Project	IEEE 802.16 Broadband Wireless Access Working Group < http://ieee802.org/16 >	
Title	Additional comments to P802.16d/D2	
Date Submitted	2003-07-16	
Source(s)	Itzik Kitroser Yossi Segal Yigal Leiba Zion Hadad Runcom Technologies Ltd. 2 Hachoma St. 75655 Rishon Lezion, Israel	Voice: +972-3-9528440 Fax: +972-3-9528805 mailto:itzikk@runcom.co.il mailto:yossis@runcom.co.il mailto:yigall@runcom.co.il mailto:zionh@runcom.co.il
Re:	P802.16d/D2 ballot	
Abstract	This contribution contains some additional changes and comments to P802.16d/D2.	
Purpose	Adopt into P802.16d/D2 draft.	
Notice	This document has been prepared to assist IEEE 802.16. It is offered as a basis for discussion and is not binding on the contributing individual(s) or organization(s). The material in this document is subject to change in form and content after further study. The contributor(s) reserve(s) the right to add, amend or withdraw material contained herein.

Additional Comments to P802.16d/D2

This contribution contains some additional changes and comments to P802.16d/D2.

Figure 128at—Example of the data region which defines the OFDMA allocation

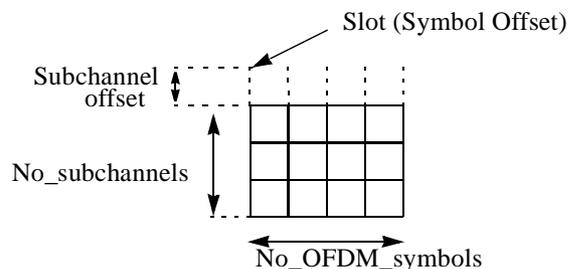
A ~~PHY burst~~ Data Region in OFDMA is a two-dimensional allocation of a group of contiguous subchannels, in a group of contiguous OFDMA symbols. This allocation may be visualized as a rectangle, such as the ~~4x3x4~~ rectangle shown in Figure 128at. ~~This type of two-dimensional allocation is called a data region.~~

[Change figure 128at as follows]

Figure 128au1—Example of mapping FEC blocks to OFDMA subchannels and symbols in the uplink and downlink

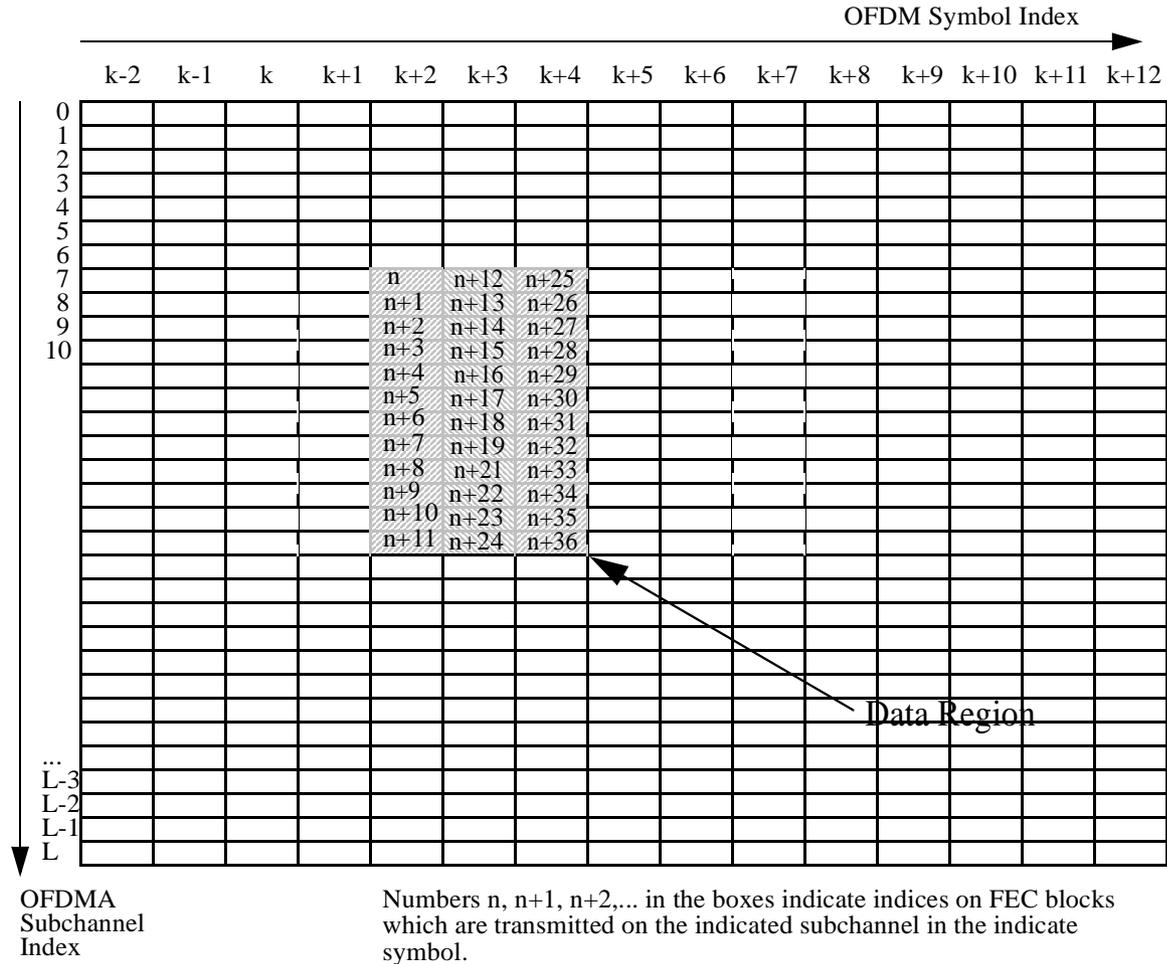
Figure 128au and Figure 128au1 illustrates the order in which FEC blocks are mapped to OFDMA subchannels and OFDM symbols.

[Add figure 128au1]

Figure 128av—Time plan - one TDD time frame

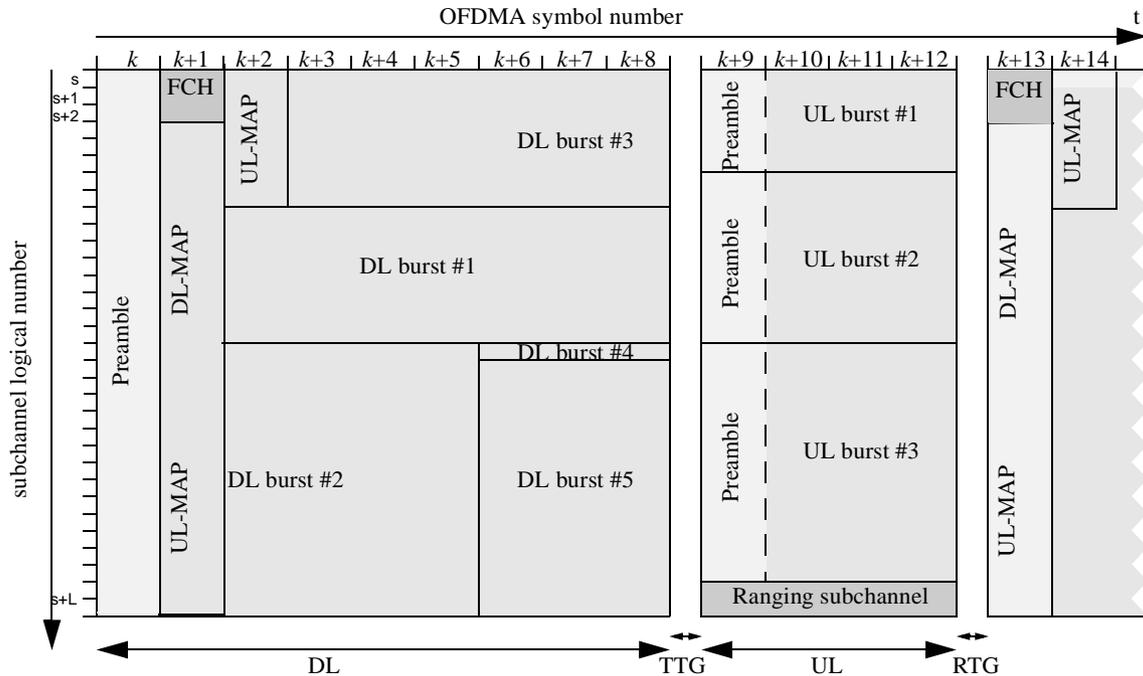
[Change figure 128av as follows]

Figure 128ay1—DL Frame Prefix sub-channel allocation for all 3 sectors

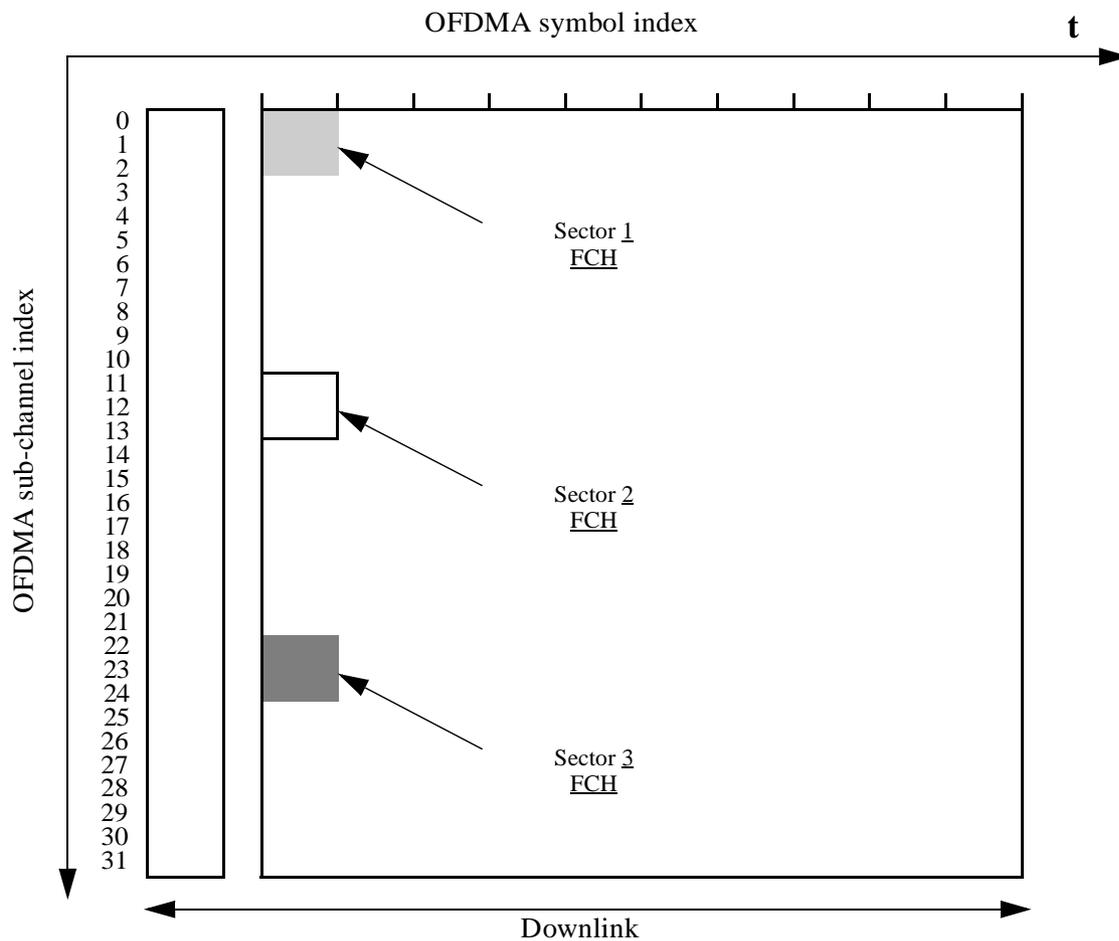
The minimal allocation of sub-channels for a sector (if the sector is used) is 3 sub-channels. The first three transmitted sub-channels in the first data symbol of the DL contains the FCH as defined in 8.5.4.2. For sector 1 Sub-channels 0-2 are used as the basic allocated Sub-Channels, for Sector 2 Sub-channels 11-13, for sector 3 Sub-channels 22-24, Figure 128ay1 depicts this structure:

Figure 128az1—Burst structure using mini-subchannel

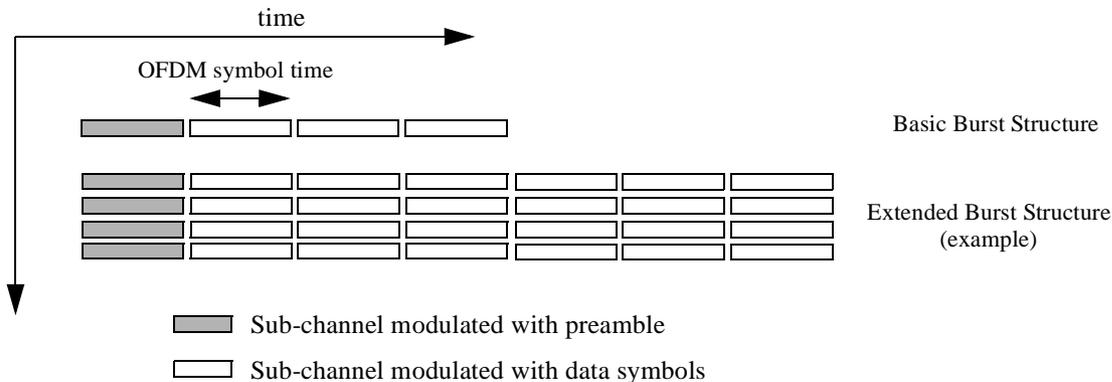
The smallest allocation when using mini-subchannels, a basic allocation, is one subchannel for a duration of 4 times the OFDMA symbol duration T_s ($N=3$). Larger allocations are called extended allocations. These allocations are illustrated in Figure 128az1.

Figure 128bb1—Sub-Channel (of 21 carriers) organization and structure

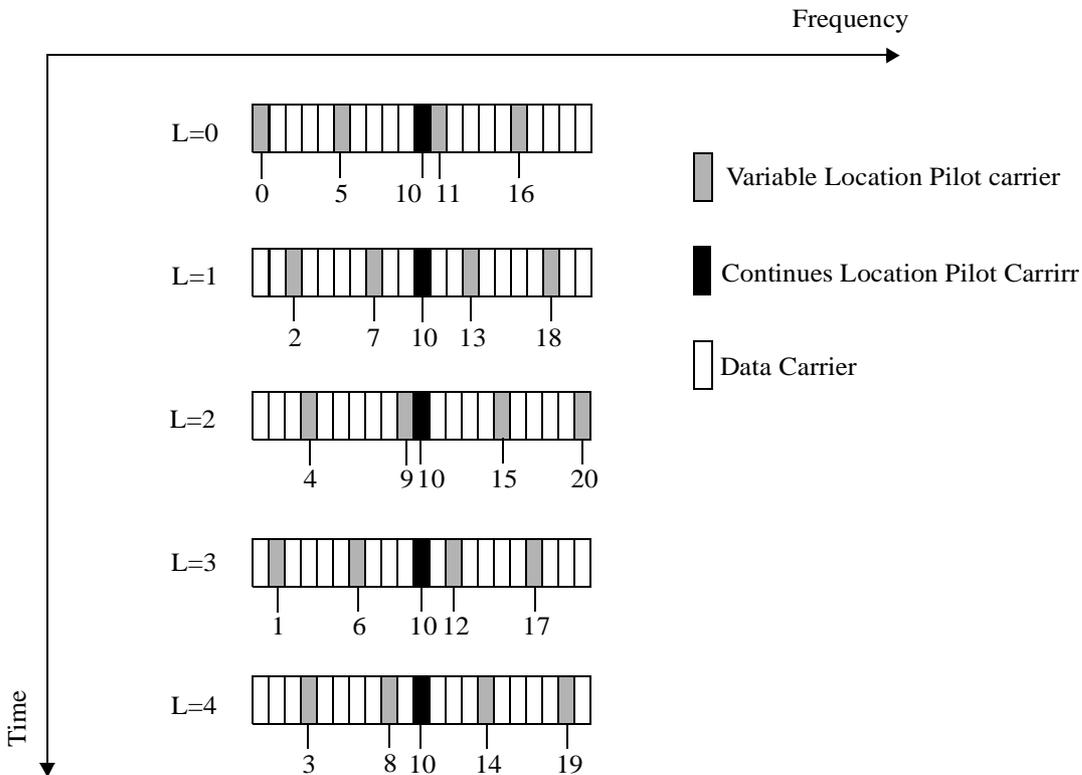
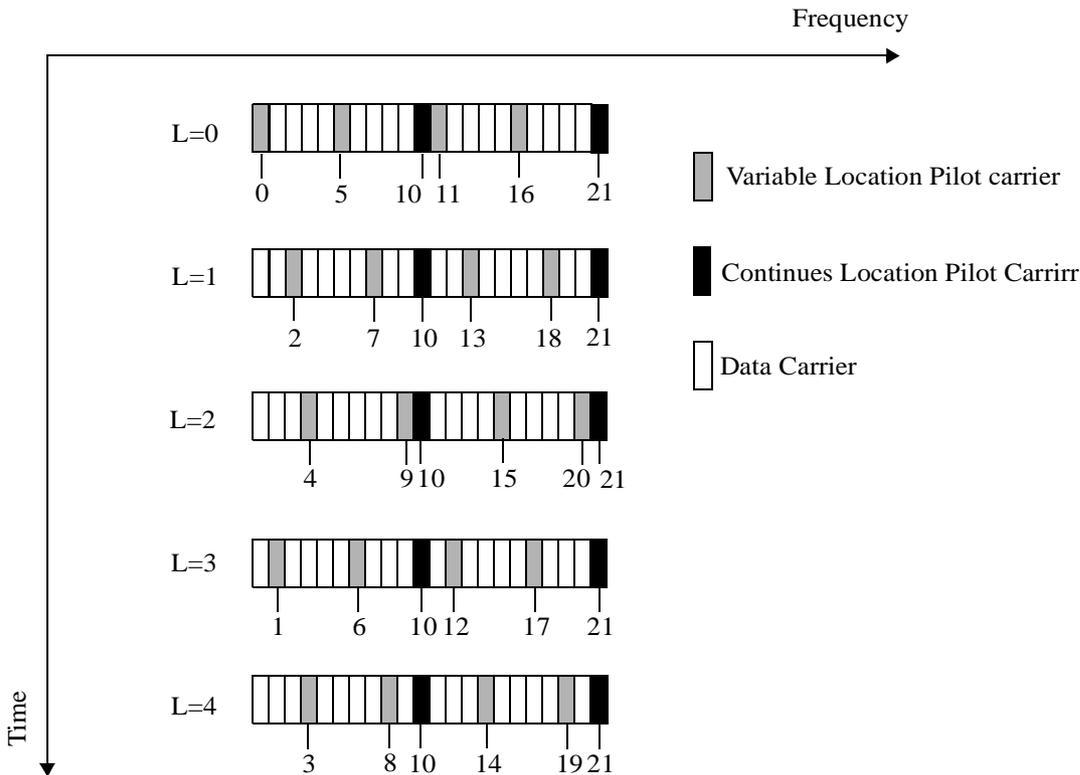
Figure 128bb1 and Figure 128bb2 depict the mini sub-channel organization:
